SYDNEY NORTH PLANNING PANEL

Panel Ref No	2017SNH011
DA Number	LDA 2016/0359
Local Government Area	City of Ryde
Proposed Development	Construction of 2 buildings of up to 6 & 9 storeys containing 96 apartments, 2 commercial units and 3 levels of basement car parking.
Street Address	39-41 Devlin Street, Ryde
Applicant	Chiwayland Australia Pty Ltd
Date of Lodgement	1 August 2016
Number of Submissions	First round notification: 5 submissions received Second round notification: 1 submission received
Recommendation	Approval
Regional Development Criteria (Schedule 4A of the Act)	General Development over \$20 Million
List of All Relevant s79C(1)(a) Matters	<ul style="list-style-type: none"> • Environmental Planning and Assessment Regulation 2000; • Environmental Planning and Assessment Act 1979; • State Environmental Planning Policy (State and Regional Development) 2011; • State Environmental Planning Policy No. 55 – Remediation of Land; • State Environmental Planning Policy (Building Sustainability Index: BASIX); • State Environmental Planning Policy No 65 – Design Quality of Residential Apartment Development; • State Environmental Planning Policy (Infrastructure) 2007 • Sydney Regional En

Figure 15: Devlin Street Elevation -Exposed doors and windows through proposed open battens to façade

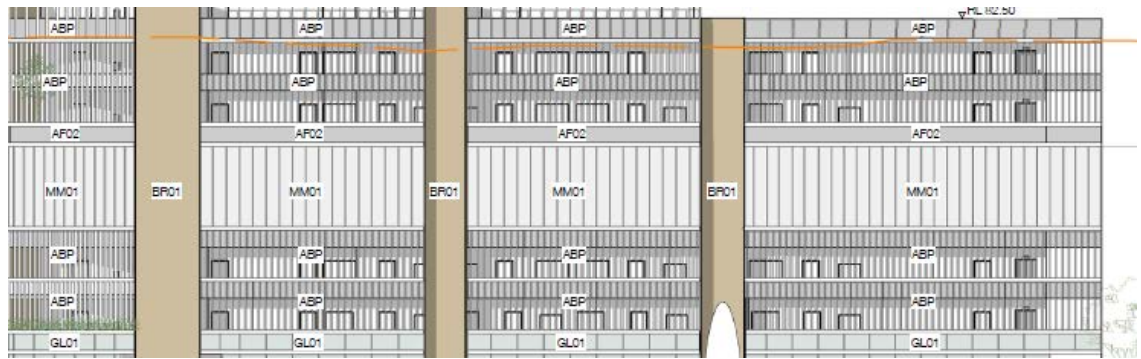
Comment: Due to the open form batters at Levels 1, 2 and 5, 6 of the building façade, the doors and windows will be visible as illustrated in **Figure 15**.

Issue J plans provide windows at 900mm above finished floor level, to be treated with frosted glazing and will sit between bench height and overhead joinery. The height of doors (lift, unit entrance and cupboard) along Devlin Street / Victoria Road frontage have been maintained on the acceptable premise that doors to lifts are a standard opening based on manufacturer's specification (2,100mm), unit entrance doors are fire rated to BCA requirements and therefore are 2,040-2,400mm based on availability from suppliers, and service cupboards will be aligned with entry doors to keep a consistent datum. This outcome is considered acceptable as demonstrated in Figure 15 below which shows the Devlin Street elevation (Issue J).

Figure 16: Section detail showing planting & plan view (Level 6) showing planter at Devlin Street and Victoria Road building intersection.

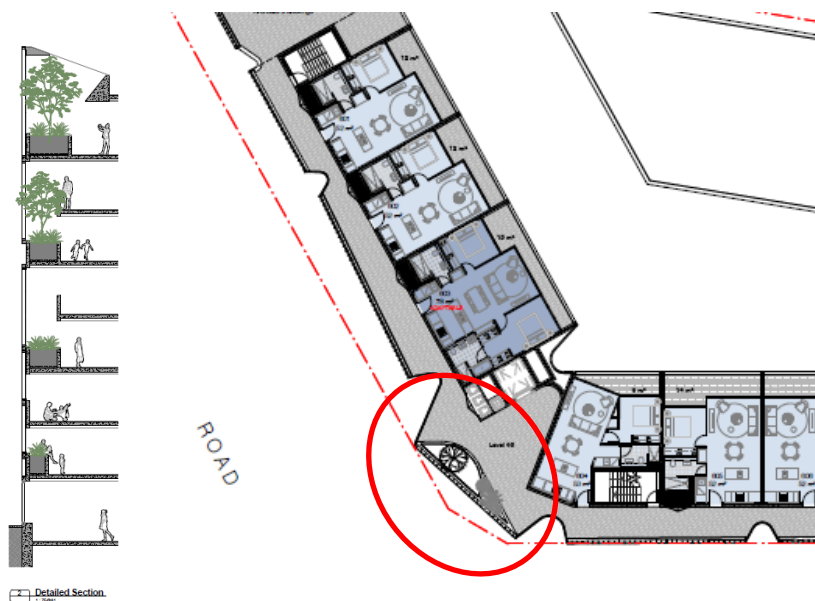
- *Question whether the planted area on some of the floors will survive as the screen will reduce solar access and they face north. Removal of the screen to this corner element at the floors with landscape would allow the greenery to be seen and to provide some relief to the facade which now appears to be just two colours only.*

Comment: As demonstrated by **Figure 16**, the landscape planter is proposed at the building corner to Levels 1, 3, 5 and rooftop. In accordance with the Victoria Road Facade Detail Plan DA0701, Levels 1 and 5 do not provide mesh screening at the building corner. Removal of the mesh to the corner at Level 3, being the central banding to the building would entirely alter the language of the façade to both Victoria Road and Devlin Street and is therefore not being pursued. The upper roof top screen has been lowered in height to RL 85.9 (refer to Point 1).

Figure 17: The above figure shows the location of the off form concrete visible to Belmore Lane (circled in red). This has been replaced with anodized aluminium louvres.

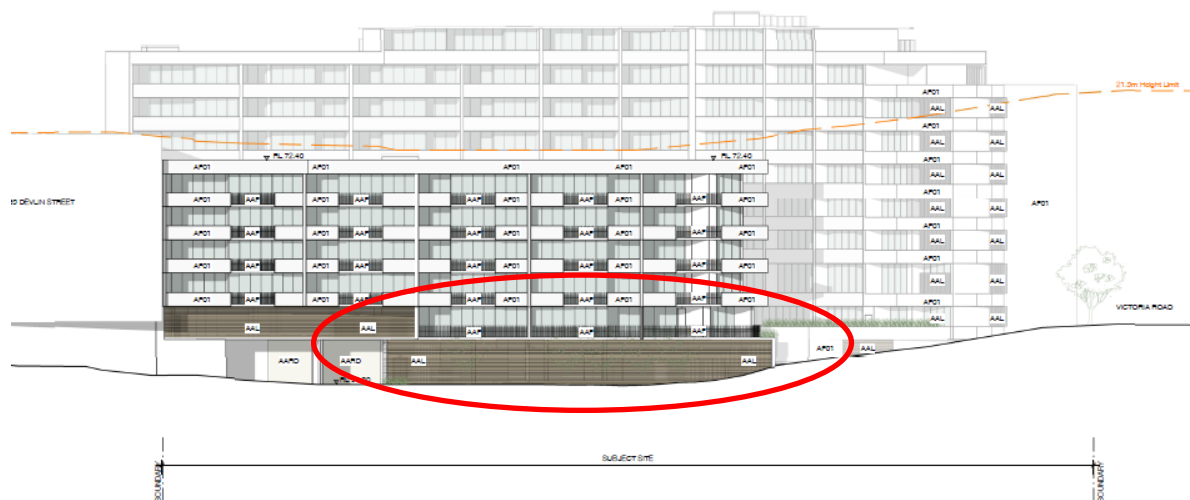
- *There is a lot of off form concrete to Belmore Lane at grade - the risk of graffiti is really high here so conditions relating to that or requiring them to continue an aluminum facade panel along instead is needed - this would give a stronger base to the building too.*

Comment: The issue G plans showed that the material finish reference AF01 is off form concrete which extends along the basement level of the Belmore Lane façade. As sought by the Panel comments this finish has been amended in Issue J to be a continuation of the aluminum façade paneling (material finish reference AAL which is anodized aluminium louvres - bronze). Condition 122 has also been imposed to assist in limiting graffiti.

Figure 18: Separation distance of building to properties across Belmore Lane

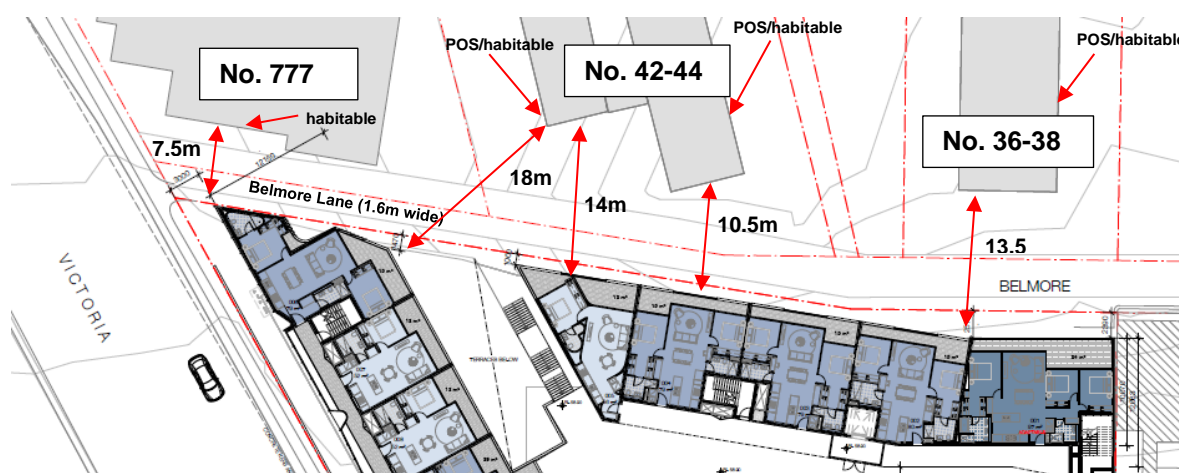
As identified in the above ADG table, the proposal does not meet the minimum separation distances to adjacent development across Belmore Lane to properties located at No. 777 Victoria Road, No. 40 and Nos. 36-38 Belmore Lane (**Figure 18**). The proposal also results in variation to the internal building separation within the development site (**Figure 22**).

Figure 20: Ground level plan showing relationship to buildings on Belmore Lane

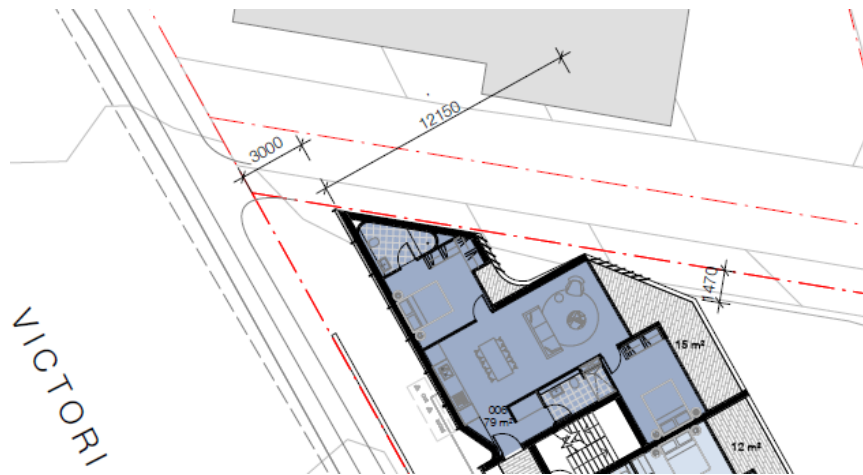
External to the site at Basement L1 to Level 5, the proposed Victoria Road building is setback 7.5m to living spaces within No. 777 Victoria Road as a result of a proposed nil setback to the north-eastern boundary. The extent of the separation is due to the laneway width (1.6m) and setback of No. 777. The existing relationship between No. 777 Victoria Road and the subject site is illustrated in **Figure 19** and the proposed building separation from Ground Level to Level 6 of the proposed development is illustrated in **Figure 20**.

The nil setback is treated with a blank wall to a bathroom. An increased setback to 8m is provided to a small bedroom balcony that is treated with angled louvres. The west facing elevation to the primary living area provides no openings with outlook and private open space oriented north away from No. 777 and where the separation (to No. 42-44 Belmore Street) achieves a distance of 18m. Notwithstanding the reduced numerical separation to No. 777, the location of uses, solid walls, orientation and louvres results in a suitable interface with existing developments across Belmore Lane. Furthermore, to create a buffer a 750mm wide planter will be required along the NW edge of the Terrace to Unit G04 (See Condition 43). This represents a far better separation and privacy solution to the earlier Issue G Plans.

Figure 11: Western Elevation to Belmore Lane (DA-0501) – solid balustrade (eg circled red)

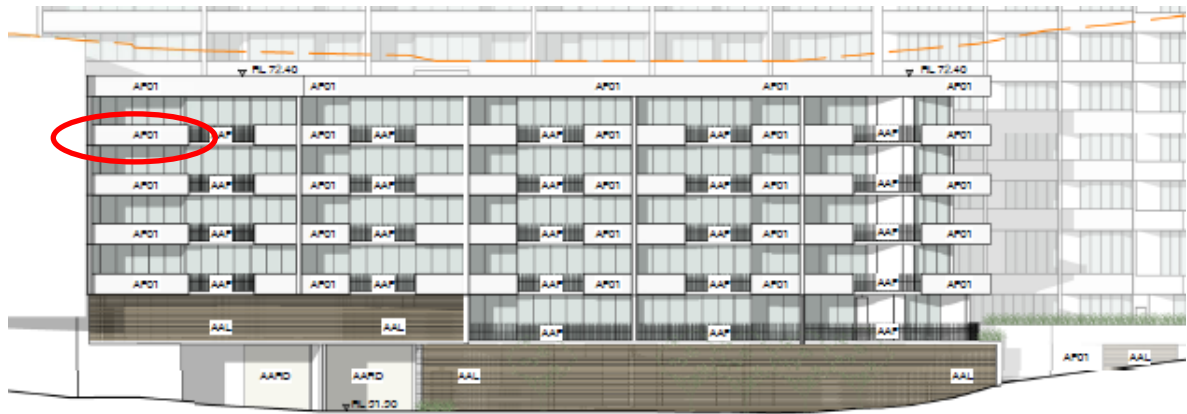
As illustrated by the Western Elevation to Belmore Lane (DA-0501), the balcony treatment to balustrades is provided with solid treatment within the primary area of the balcony (**Figure 21**). In light of the stated objective above, the separation and relationship between the proposed development and No. 42-44 and Nos. 36-38 Belmore Street is considered acceptable and will not result in privacy conflict, particularly given the orientation of those buildings which turn their back on the development.

Figure 12 Internal separation distance between proposed buildings (eg. Level 3 – DA-0206)

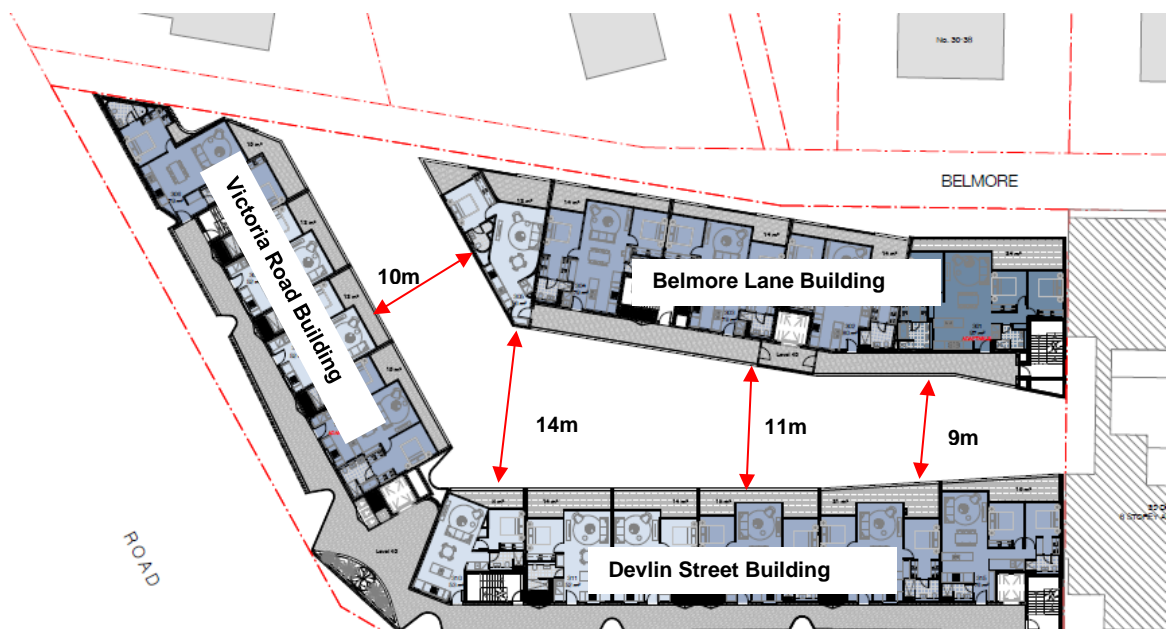
Internal to the site, due to the arrangement of the buildings, the separation between the Devlin Street Building and Belmore Lane Building is variable ranging from 9-14m from Ground Level to Level 3 (**Figure 22**). This relationship is supported given the proposed units within the proposed Devlin Street / Victoria Road buildings adjoin a solid wall or access corridor to the proposed Belmore Lane Building with primary living areas within the Belmore Lane building oriented to the north-west (Laneway) away from the opposing buildings. It is noted that the Victoria Road Building opposes a blank wall to the Belmore Lane Building to solid wall at a distance of 7.5m (ground) to 10m (Level 1-3), acceptable under the ADG.
